# ROAD SAFETY AUDIT RESPONSE REPORT

**December 2014**

Location:	Southam Road, Banbury	Scheme:	Supermarket Development
Drawing numbers:	26004/2001/001	Project number:	26004
Site visit:	Yes Date: 02-12-14	Weather:	Cold with light rain fall

**LAND AT MONDELEZ INTERNATIONAL  
SOUTHAM ROAD, BANBURY  
PROPOSED ACCESS JUNCTIONS &  
SWEEP PATH ANALYSIS**

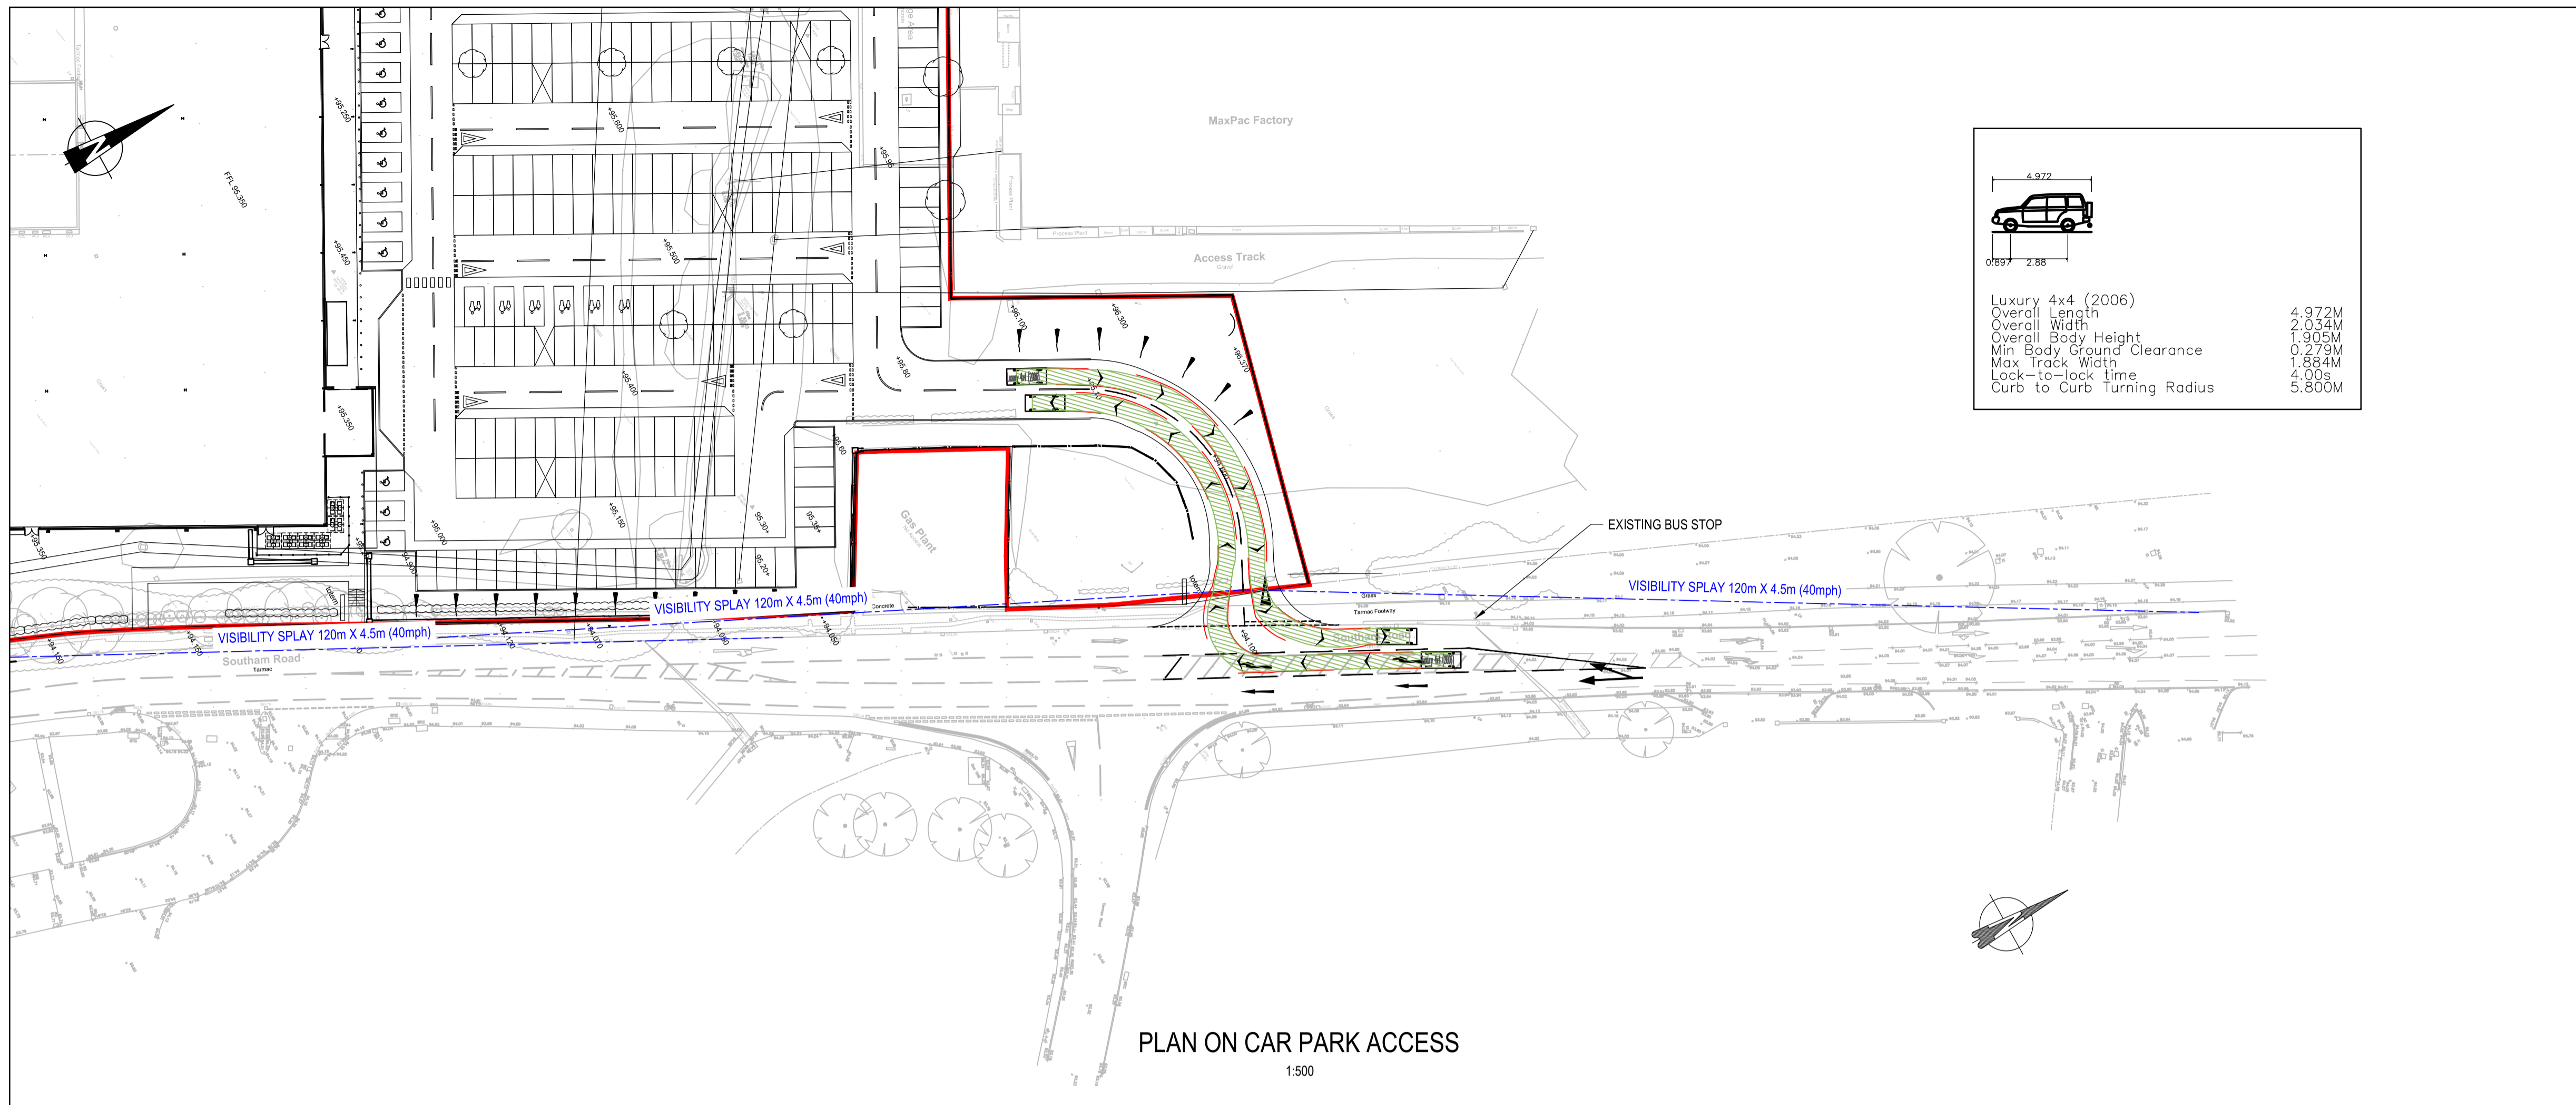
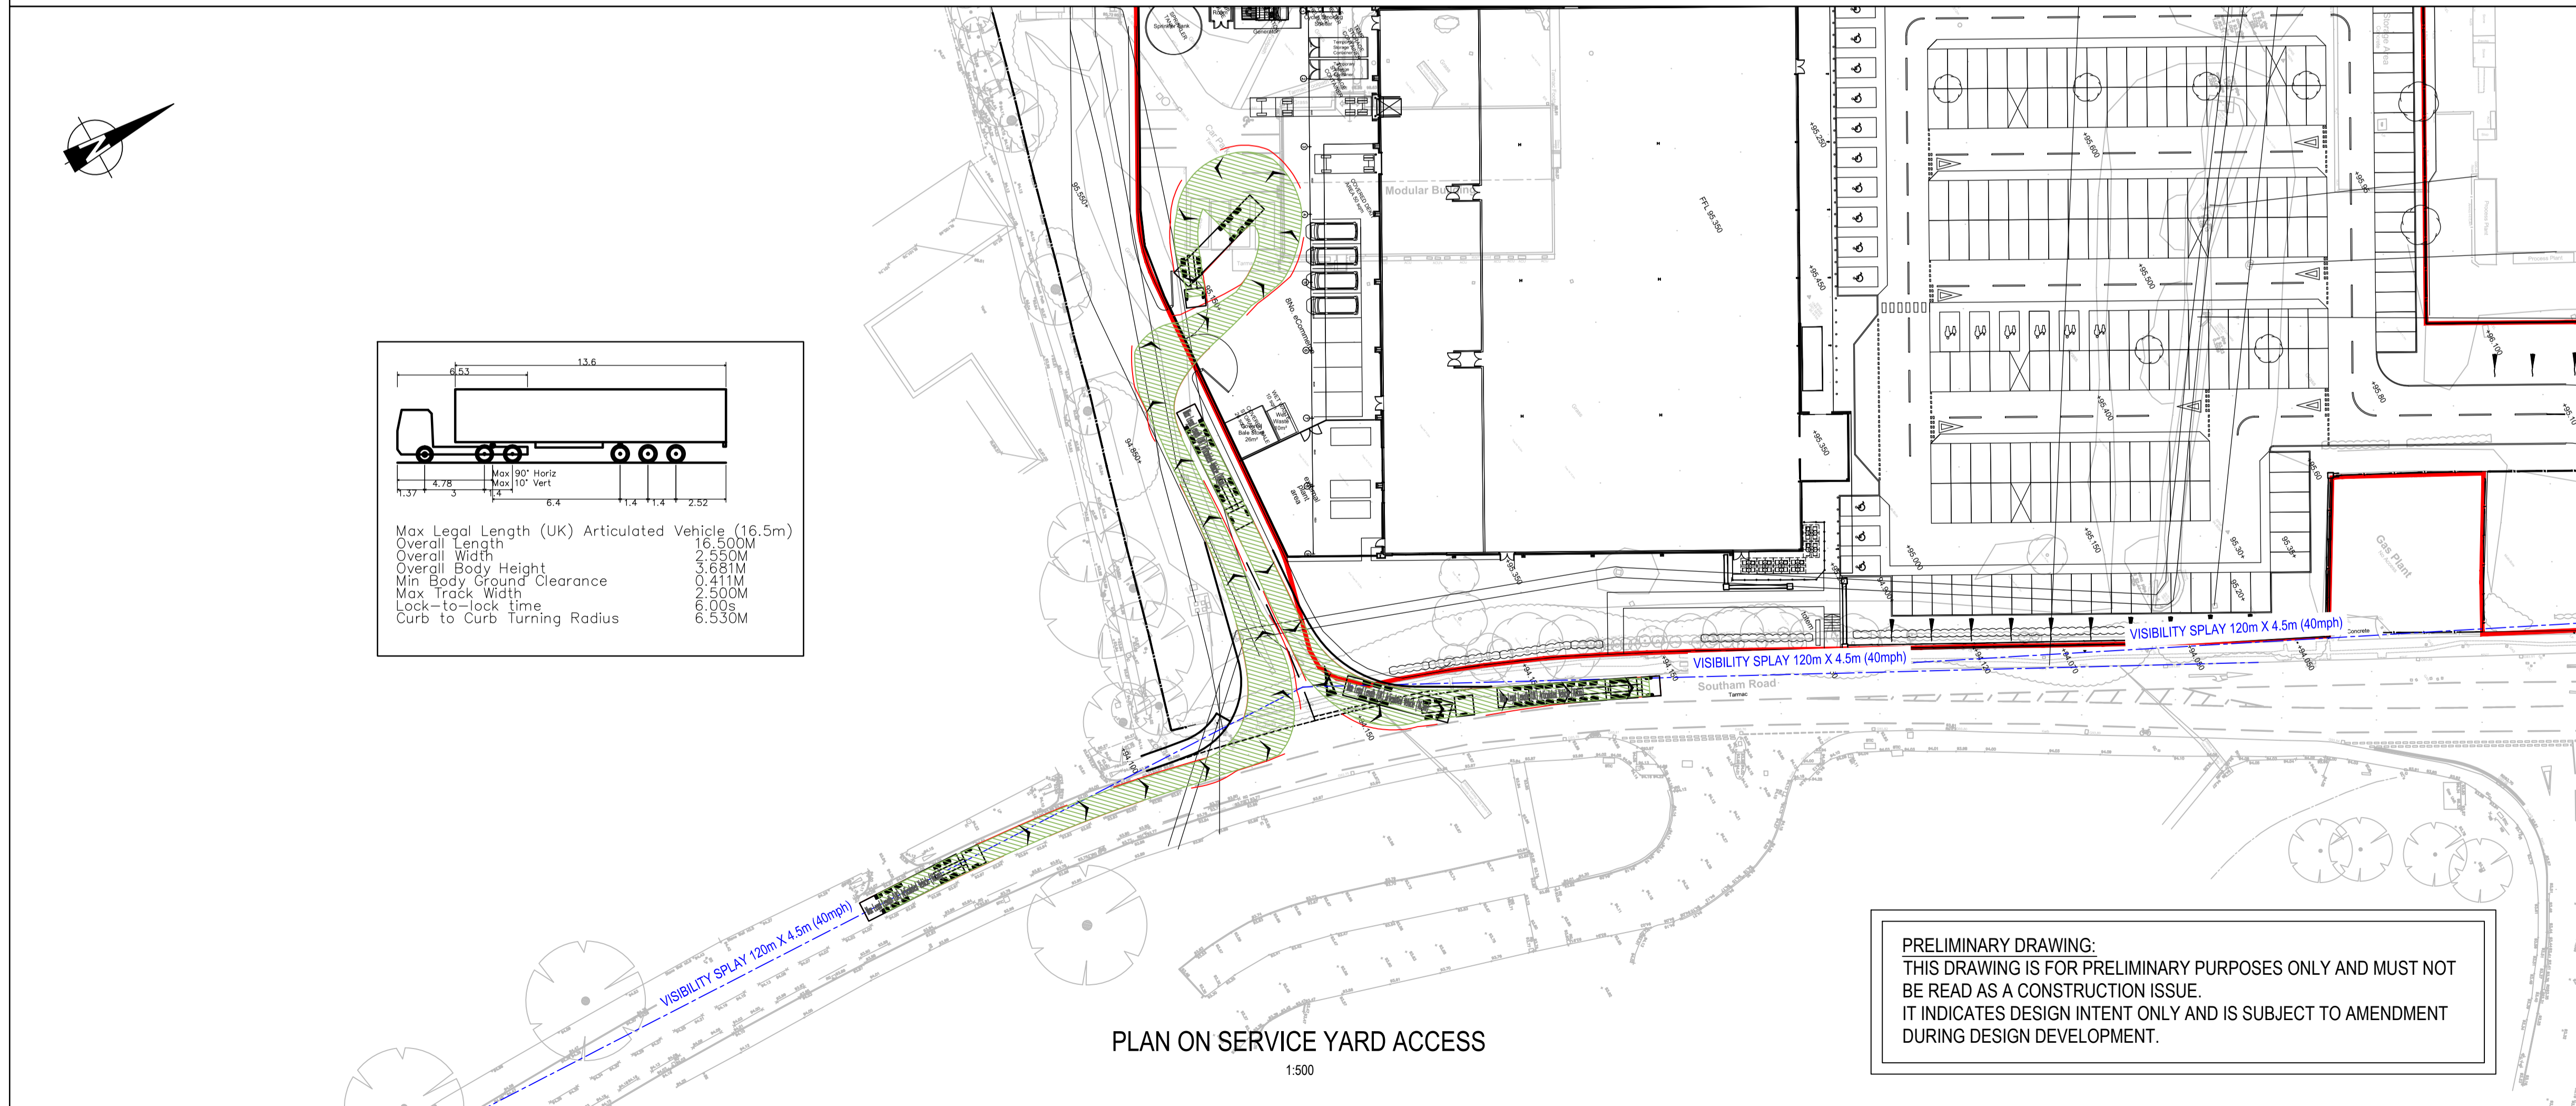
2.1	<p><b>Summary - Increase multiple collision types incidents due to junction types</b></p> <p>Stage 1 RSA Recommendation</p> <p>In the absence of a Transport Assessment, the Audit Team would recommend altering the proposed form of the Southam Road / Marley Way / Car Park Access junction from a staggered junction, to a roundabout or signalised junction.</p>	<p>The Transport Assessment (TA) has now been completed and OCC consulted on the form for the junction at the site access.</p> <p>The findings of the TA show that the priority junction proposed is an appropriate form for the junction to serve the proposed scheme.</p> <p>OCC have confirmed that the layout and type of junction is acceptable for the development proposed and for the design to comply with Manual for Streets rather than DMRB.</p> <p>However, notwithstanding the above the design as proposed is compliant with DMRB with regards to the geometry and visibility requirements.</p> <p>It has been agreed with OCC that in the context of the local highway network, that the manoeuvring requirements of an 18.35m drawbar trailer combination is not relevant for this scheme. Both the minor arms are private roads and not adopted highway. Furthermore, the access to the proposed store is for the car park and not for deliveries.</p>

2.2	<p><b>Summary - Junction visibility restricted leading to failed to Give Way type collisions</b></p> <p>Stage 1 RSA Recommendation</p> <p>Full and unrestricted junction visibility splays should be provided within the extent of the adopted highway boundary for this 40mph road. These visibility splay should be safeguarded by undertaking any necessary vegetation reduction / removal of overhanging branches.</p>	<p>The current masterplan (14334-6000-C), and junction layout has been developed to provide for visibility splays in accordance with DMRB and includes the removal of existing trees in the vicinity of the proposed junctions.</p> <p>The design will be reviewed during detailed design as required.</p>

2.3	<p><b>Summary - Insufficient width of proposed turning lane leading to shunt and side swipe collisions</b></p> <p>Stage 1 RSA Recommendation</p> <p>The width of the turning facility should be increased in order to comply with the requirements stated within Mandatory Item 7.35 of TD 42/05 for this new junction</p>	<p>After further assessment, there is sufficient room to accommodate a 3m right-hand turning lane for the entire turning length as stated in Item 7.35.</p> <p>The design will be reviewed at detailed design stage as required.</p>

2.4	<p><b>Summary - Increase in entry width resulting in multiple collision types at the junction</b></p> <p>Stage 1 RSA Recommendation</p> <p>The Audit Team recommend that this facility is increased in width. Gully grates could be</p>	<p>This is an existing issue and will not be affected further by the proposed scheme. Therefore, this falls outside of the current stage of works</p>

<p>replaced with kerb outlets (associated gully pots relocated).</p> <p>Road markings, including Diag 1057 (cycle symbol) should be reapplied. A coloured surface should be provided across the Southam Road / Marley Way junction to help increase the conspicuity of this facility and increase driver awareness of cyclist as per 7.3.2 of LTN 2/08</p>

2.5	<p><b>Summary - Vulnerable pedestrians in danger of being struck by other road users</b></p> <p>Stage 1 RSA Recommendation</p> <p>Uncontrolled crossing points should be provided inset into the minor roads. If possible, the corner radii forming the junctions should be reduced in order to locate these crossing points closer to the direct NMU desire line.</p> <p>Appropriate tactile paving should also be provided as part of the details of the pedestrian ramp and steps between Southam Road and the car park.</p>	<p>This will be reviewed at detailed design stage, and appropriate crossing details provided.</p>

2.6	<p><b>Summary - Lack of crossing facilities could result in NMUs being struck by other road users</b></p> <p>Stage 1 RSA Recommendation</p> <p>An assessment (such as LTN 1/95 – ‘The Assessment of Pedestrian Crossings’) should be undertaken to determine the need and appropriate form of crossing facilities required</p>	<p>This will be reviewed at detailed design stage.</p>

across Southam Road. Following this assessment, the proposed junctions should be amended to accommodate the outcome of this assessment if necessary. Any proposed crossing provisions should consider and accommodate the existing bus stops located to the north of the proposed Car Park junction, as well as the Public Right of Way on the south side of the proposed Service Access

2.7	<p><b>Summary - Incomplete swept path analysis</b></p> <p>Stage 1 RSA Recommendation</p> <p>The swept path analysis should be repeated in response to the above in order to confirm that the proposed layout is suitable with any subsequent alterations to the design undertaken as necessary to ensure vehicles do not strike kerbs, overhang potential off carriageway NMU provisions, etc.</p>	<p>Tracking has been undertaken at 5mph for the scheme. The largest appropriate vehicles have been tracked and appropriate changes recommended made in the final masterplan ref 14334-6000-C to accommodate these.</p> <p>Not all tracking is shown for clarity of drawings.</p> <p>Additional tracking will be completed at detailed design.</p>

The TA and OCC's comments confirm that the proposed junction form is appropriate and a roundabout or signalised junction need not be considered further.

**LAND AT MONDELEZ INTERNATIONAL,  
 SOUTHAM ROAD, BANBURY  
 PROPOSED ACCESS LEVELS**

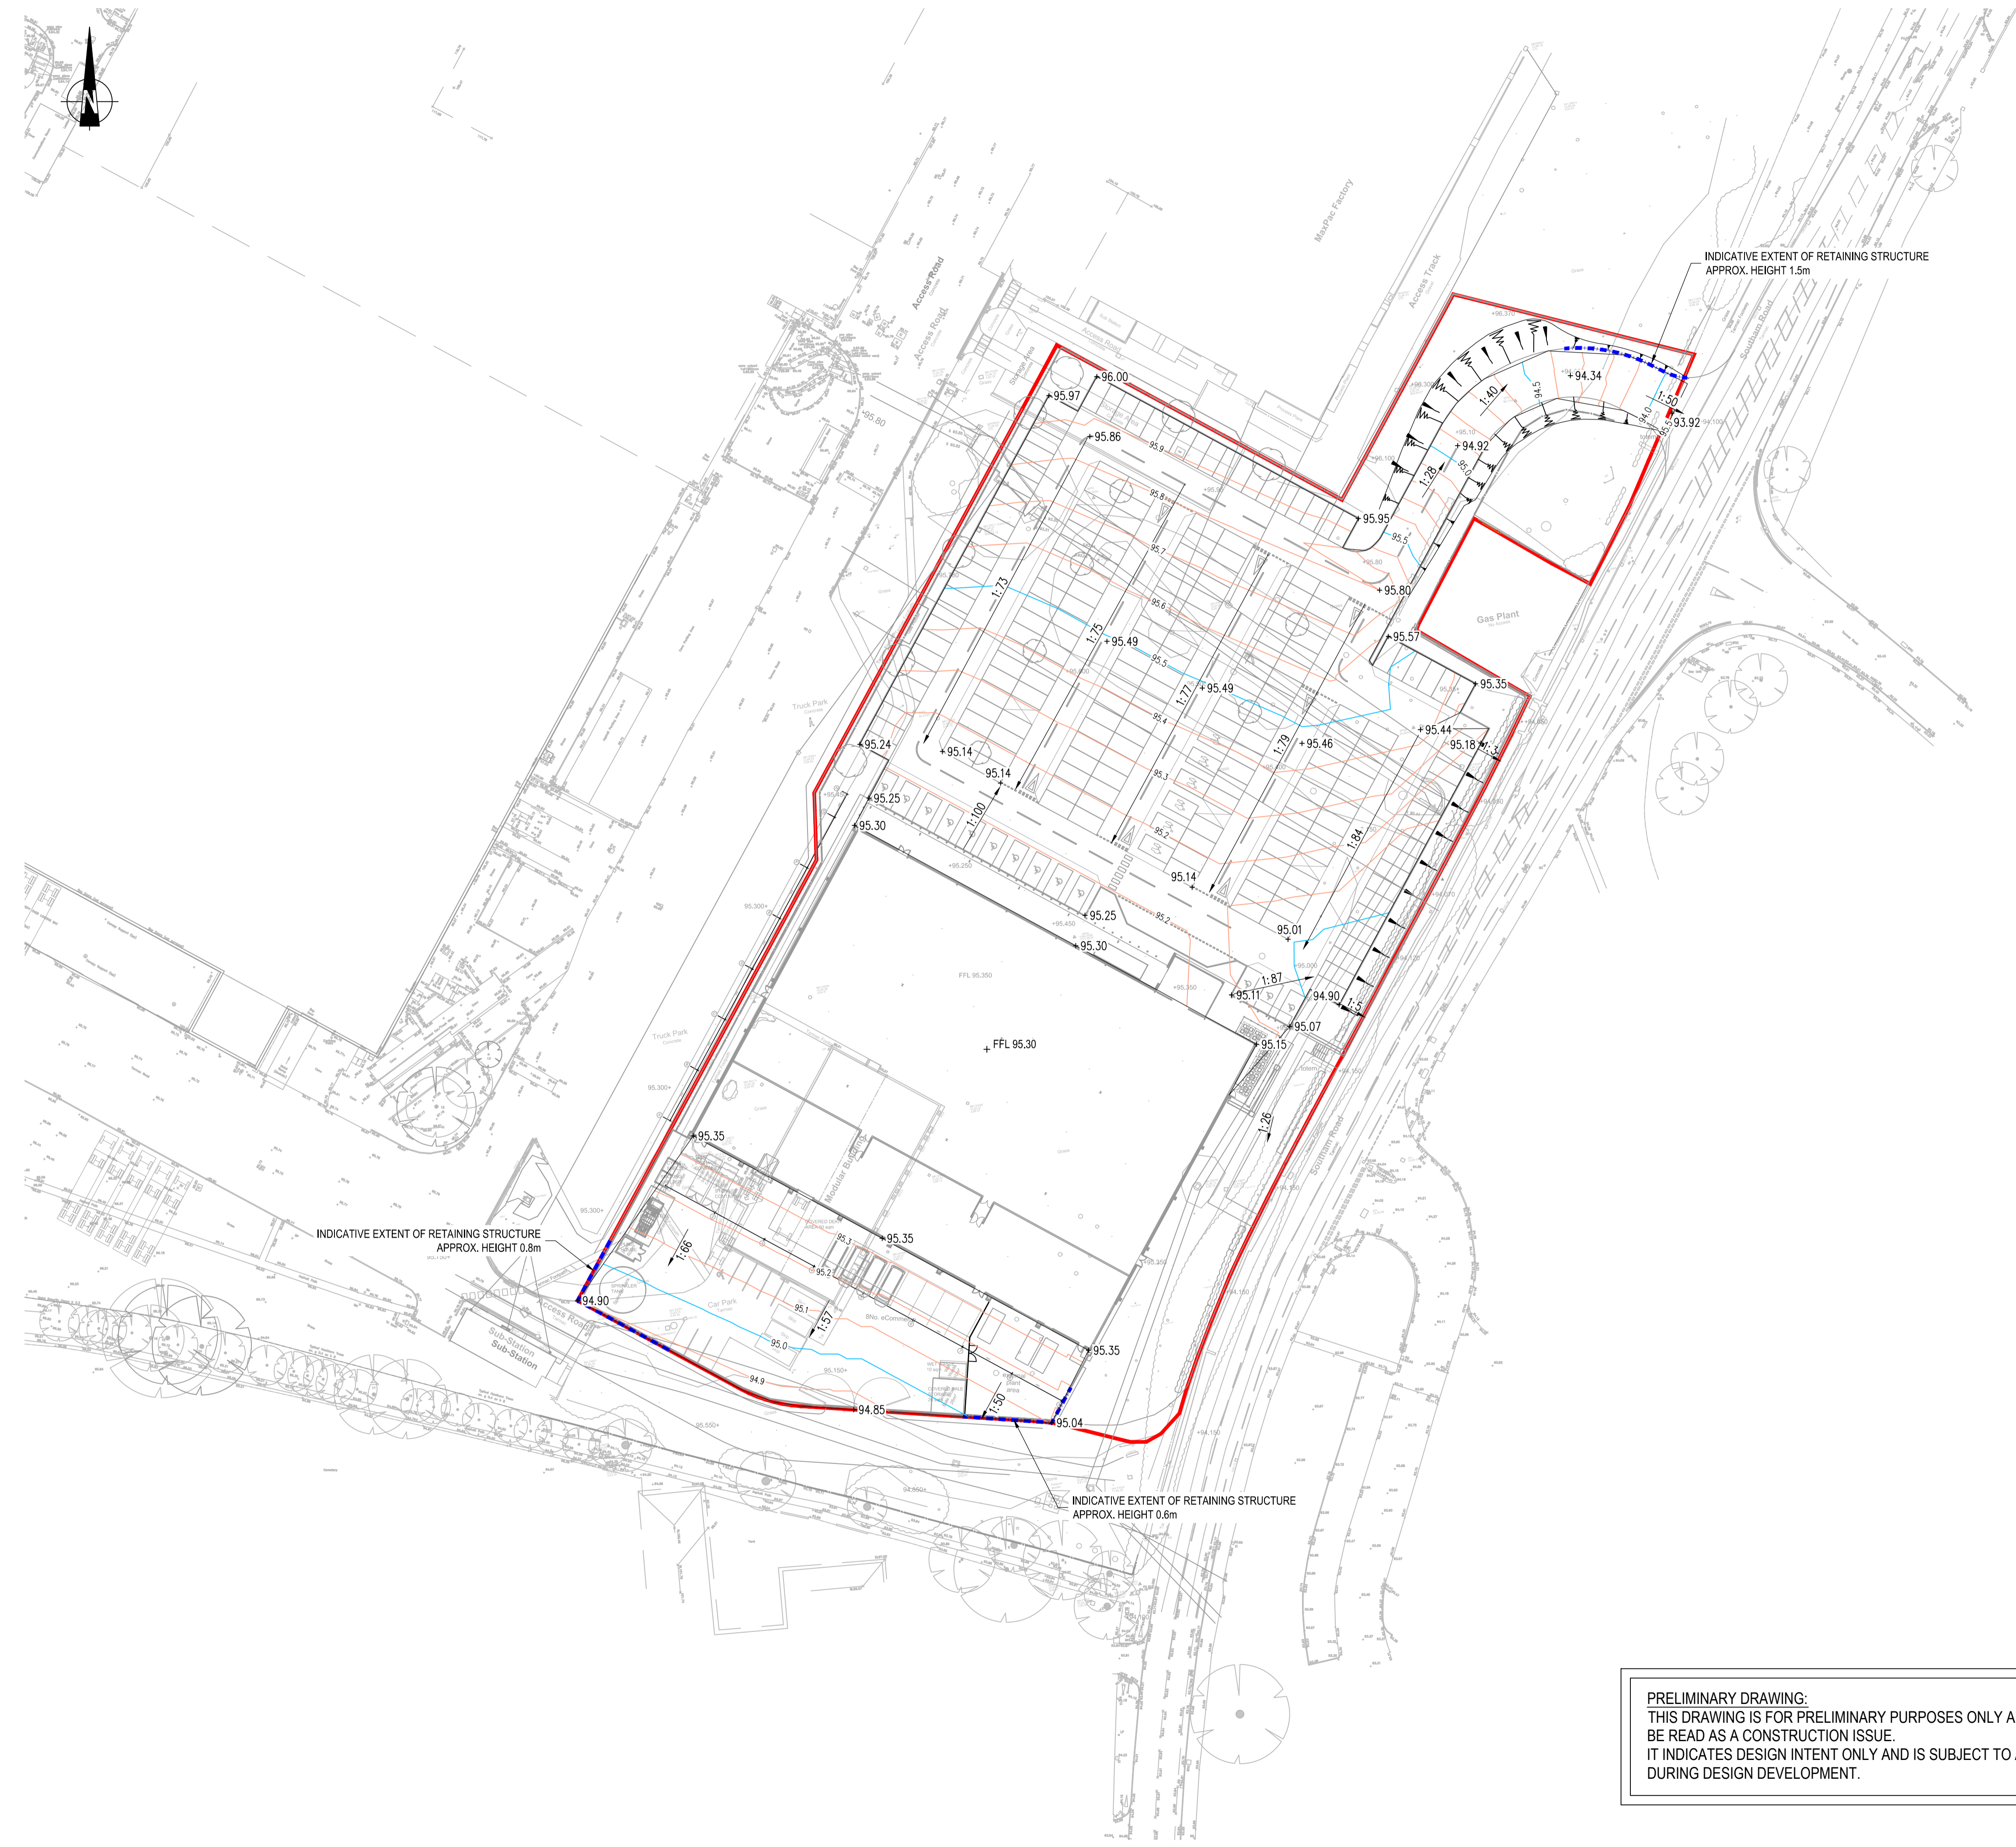
2.8	<p><b>Summary - Drafting error</b></p> <p>Stage 1 RSA Recommendation</p> <p>This assumed draft error should be corrected.</p>	<p>Error in architects layout has been highlighted and correct levels are shown on drawing 26004-2001-003.</p>	
	Auditor: <b>Simon Owen</b>	Design Engineer: Anne Farmer	Scheme Promoter:
	Date: <b>02/12/14</b>	Date: 11/3/15	Date
	Signed:	Signed:	Signed:
